PUEBLO CITY-COUNTY
LIBRARY

PUEBLO CITY-COUNTY
LIBRARY
ISSUED FOR:
100% CONSTRUCTION
DOCUMENTS

SHEET TITLE:
TYPICAL FLOOR PLAN

A2.1

1 TYPICAL FLOOR PLAN
1/8" = 1'-0"

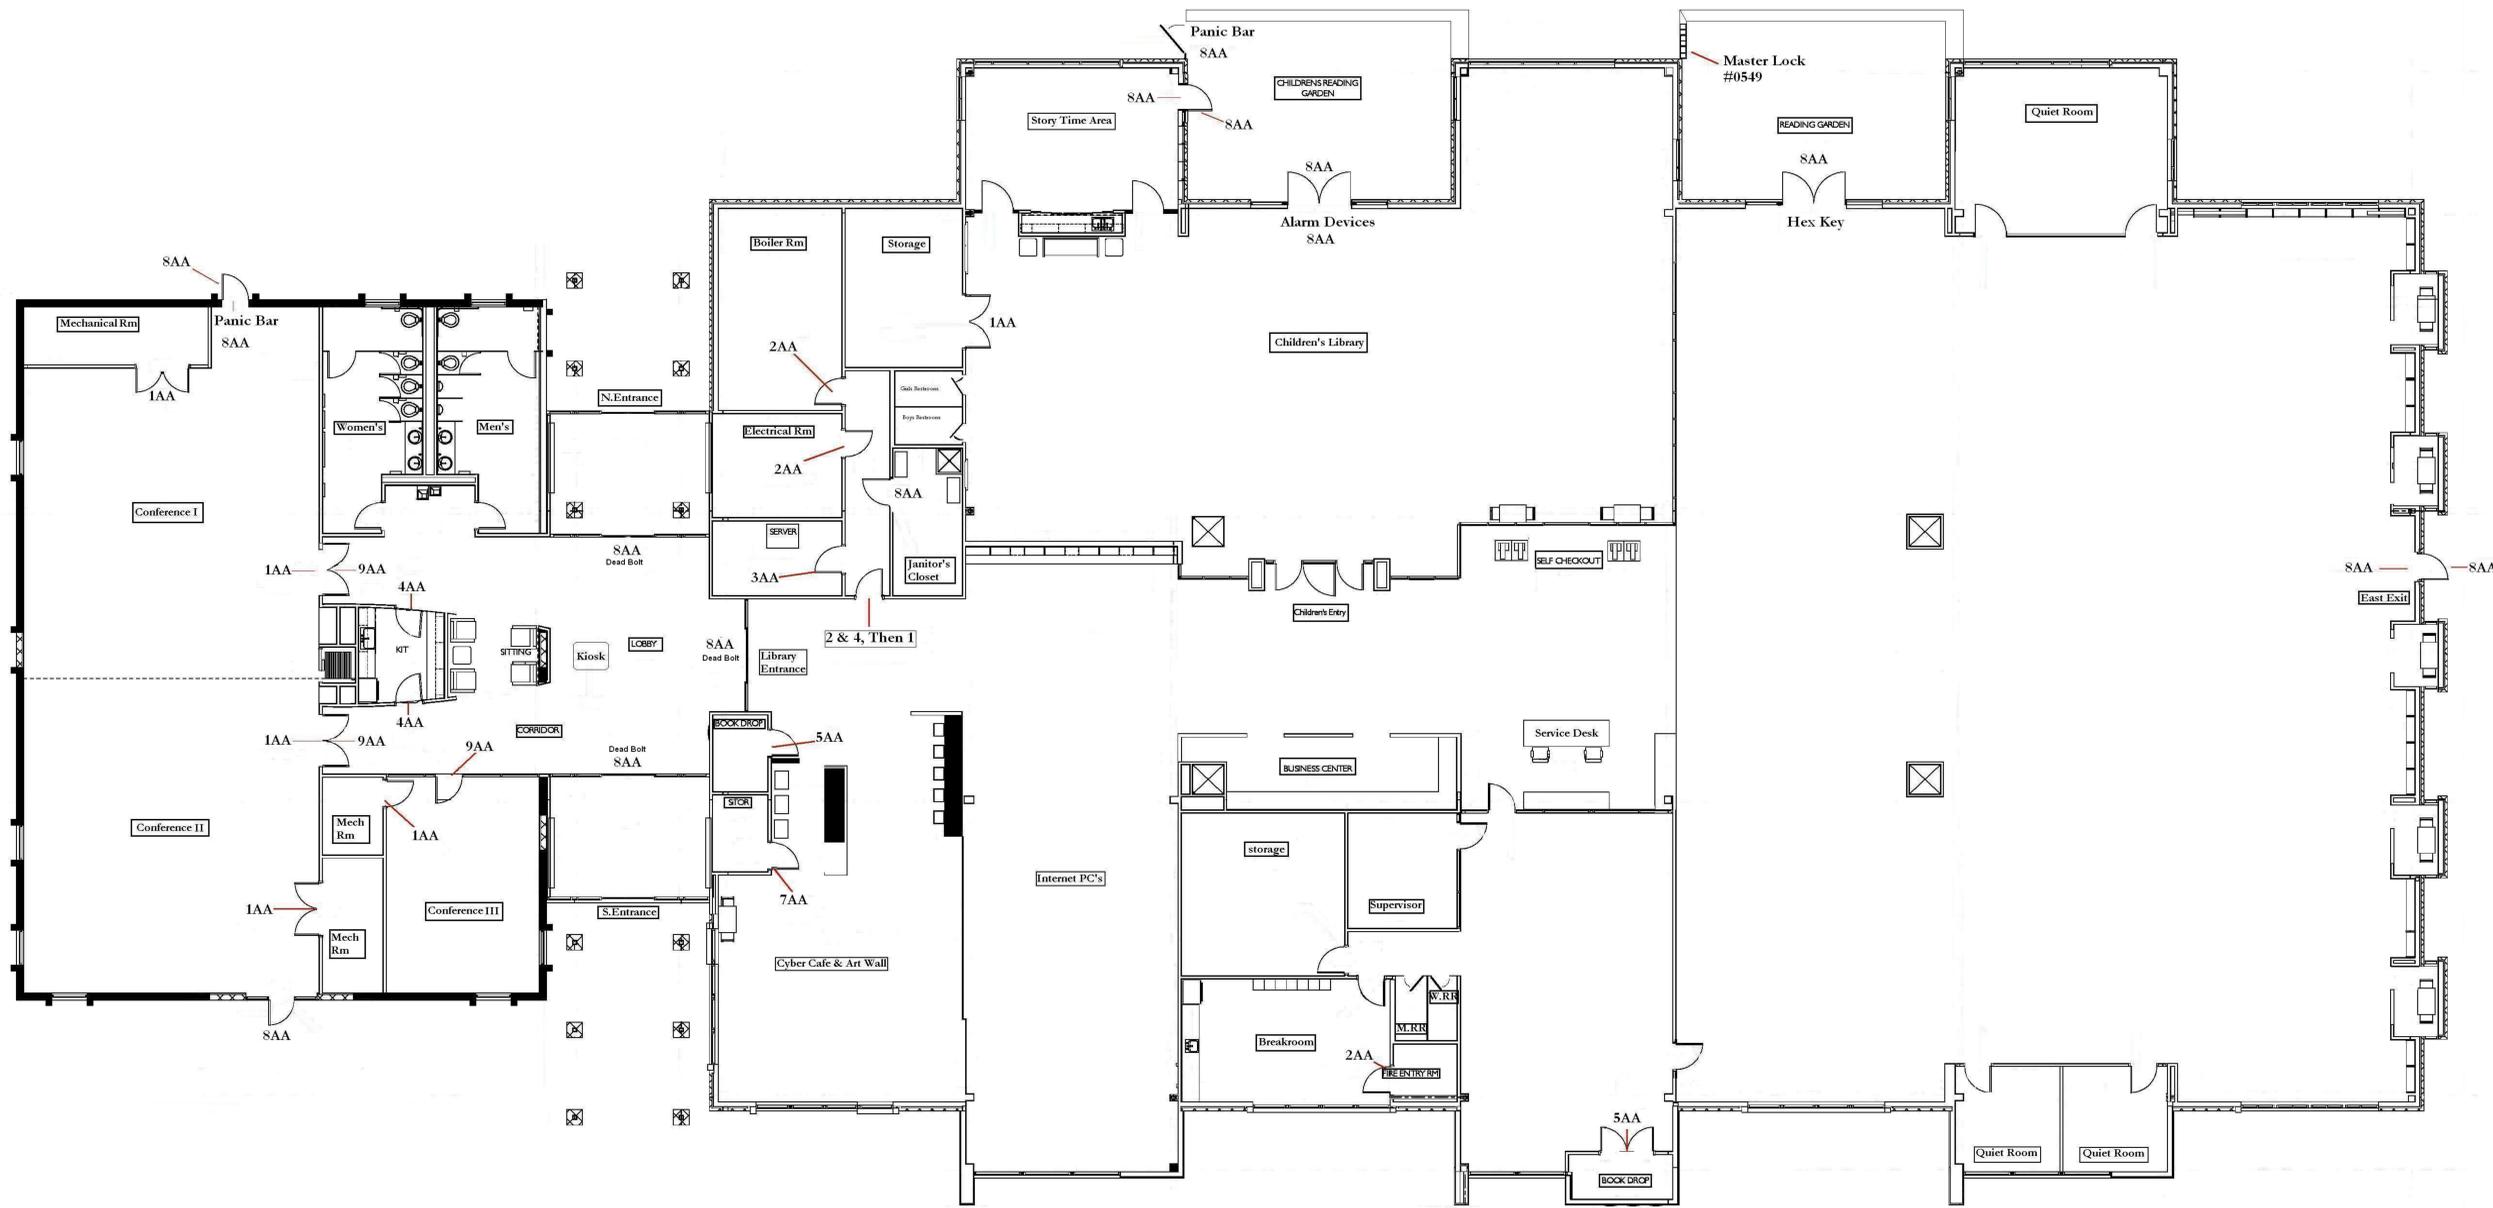
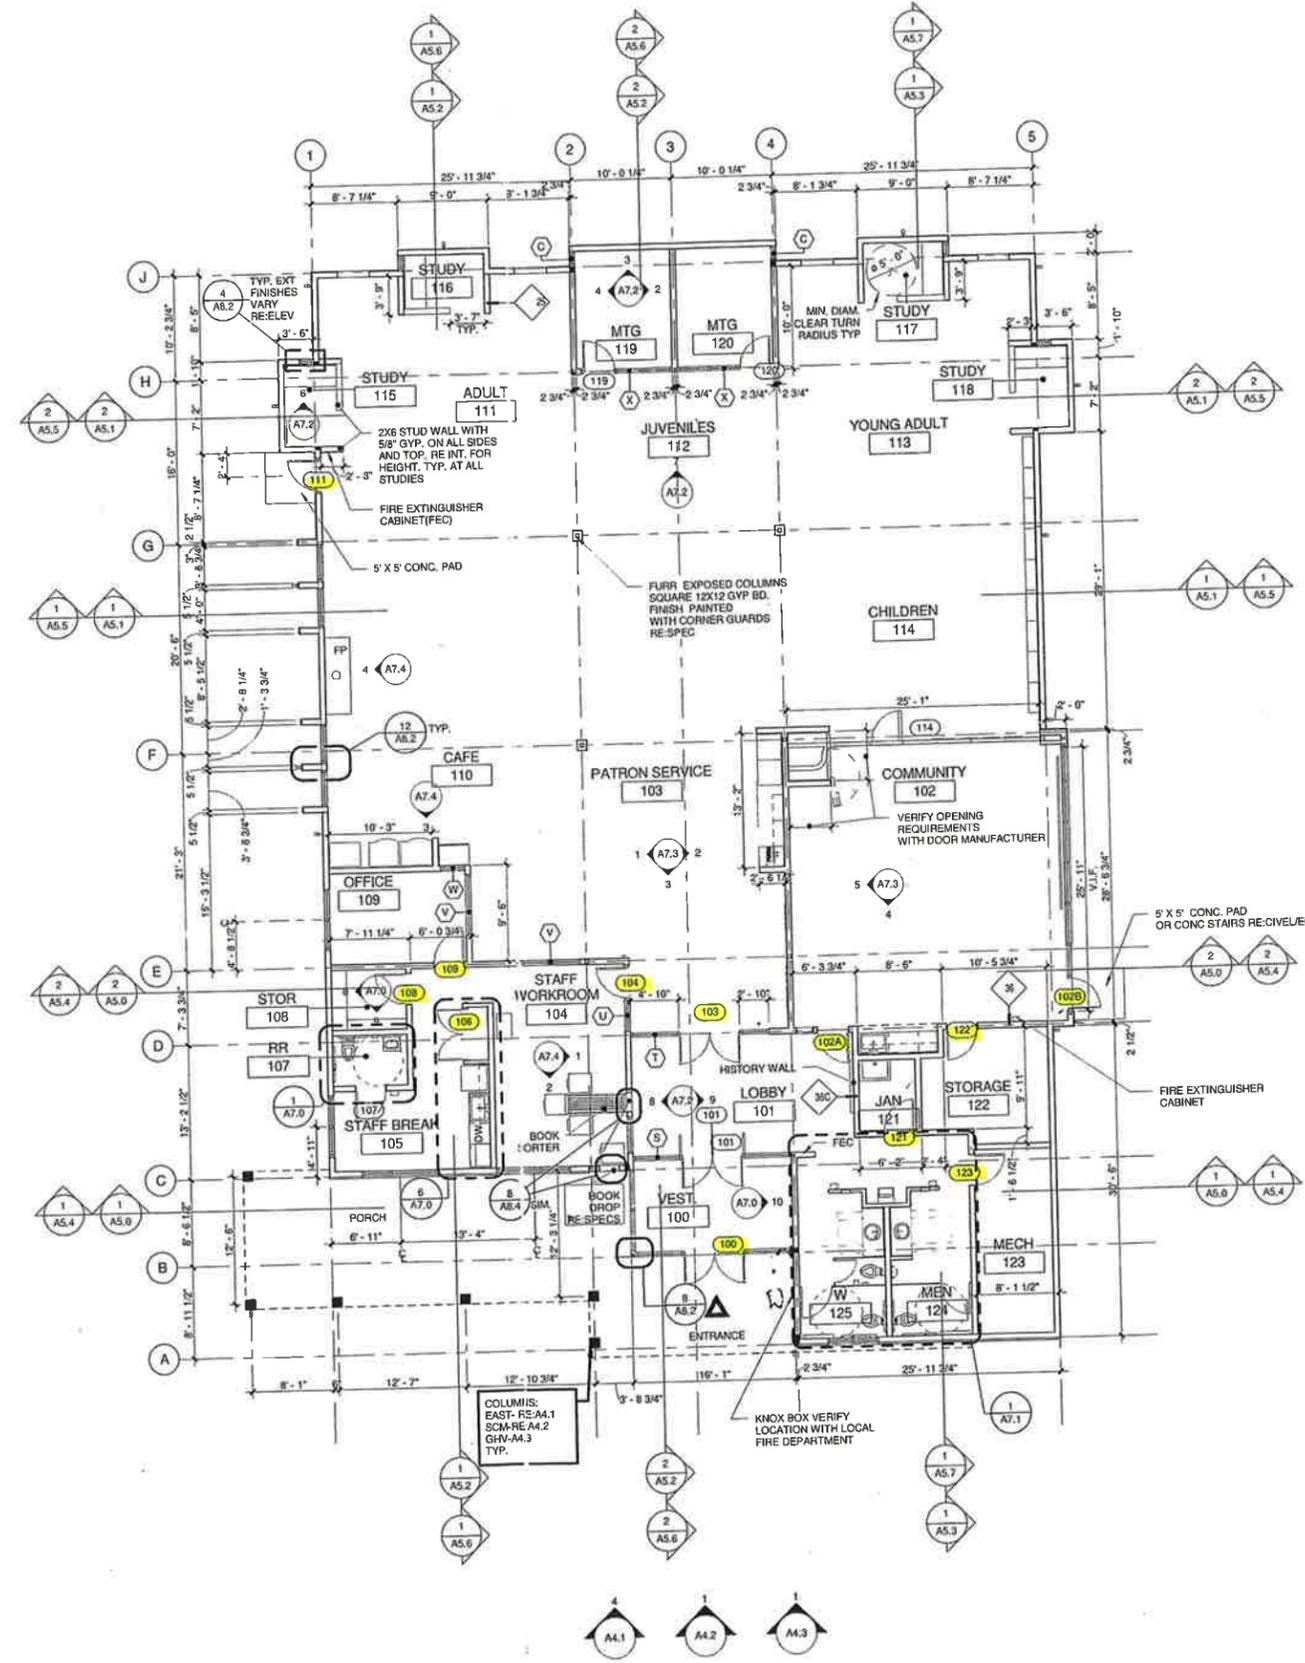
REVISIONS TO CONSTRUCTION SET:

- ALTERNATE FRONT PORCH AREA SHOWN IN DRAWINGS WITH LOW SLOPE ROOF.
- ADDED GUTTER AND DOWNSPOUT TO FRONT ROOF.
- LOWERED WINDOW HEADS ON ALL THREE BUILDINGS

- CLARIFIED 1.5" DIAM EXTERIOR STEEL HANDRAIL AND GUARDRAIL
- ADDED WOOD SILL AT WINDOW-RE DETAILS
- CHANGED CAP ON U/A.3 BETWEEN GRID 1 AND 2 FROM MTL TO STONE-GHV

- ADDED ATTIC ACCESS PANELS AT SCISSOR TRUSS ATTIC SPACE
- STOREFRONT TYPE F CHANGED FROM 8'-0" h x 6'-4" w to 3'-6" h x 6'-4" w.
- STOREFRONT TYPE G CHANGED FROM 8' high, to 7' high (all 3 buildings)

- STOREFRONT TYPE H TRANSOM REMOVED
- STOREFRONT TYPE R CHANGED FROM 6'-7" high to 4'-6" high.
- STOREFRONT TYPE W CHANGED FROM 3'-6" w to 3' w
- DOOR 111 CHANGED FROM 8' high, to 7' high

- DOOR 102B CHANGED FROM 8' high, to 7' high
- DOOR 114 CHANGED FROM 10' high to 9' high
- ACOUSTIC PANELS ON CEILINGS HAVE BEEN REMOVED
- ALTERNATE FIREPLACE SHOWN IN DRAWINGS

- ACOUSTICAL CEILING GRID ADDED AT EAST SIDE IN THE ADULT, YOUNG ADULT AND COMMUNITY ROOM. GYP. BD. REMOVED ABOVE
- ADDED DOWNSPOUT ON WEST ELEVATION (ALL 3 BUILDINGS)

- 8" CEILING EXTENDED OUT INTO MENS AND WOMENS RESTROOM
- GHV NORTH ELEVATION CHANGE FROM STONE TO STUCCO.
- PROVIDE SCHLUTER JOLLY TRIM ON OUTSIDE TILE CORNERS IN RESTROOMS.

- ADDED ADJUSTABLE SHELVING TO SOUTH WALL OF STORAGE 108.
- DELETED SHELVING IN STORAGE 122.
- ADDED ACCENT CARPET TILES AND PATTERNS IN EAST SIDE.
- REDUCED CASEWORK SIZE AND WINDOW SIZE AT CAFE 110 TO ACCOMMODATE AN ADDITIONAL VENDING MACHINE (PROVIDED BY OWNER).

- REDUCED LOWER CABINET SIZE AT PATRON SERVICE 103 TO FIT ADDITIONAL OWNER-PROVIDED EQUIPMENT. ADJUSTED UPPER CABINET SIZES.
- REMOVED CASEWORK ON EAST WALL OF STAFF WORKROOM 104.

- FURRED OUT AND ADDED CORNER GUARDS TO COLUMNS G2, G4 AND F2.
- REMOVED WC-02 TAC WALL AND ALUMINUM TRIM AT WEST WALL OF WORK ROOM 104.
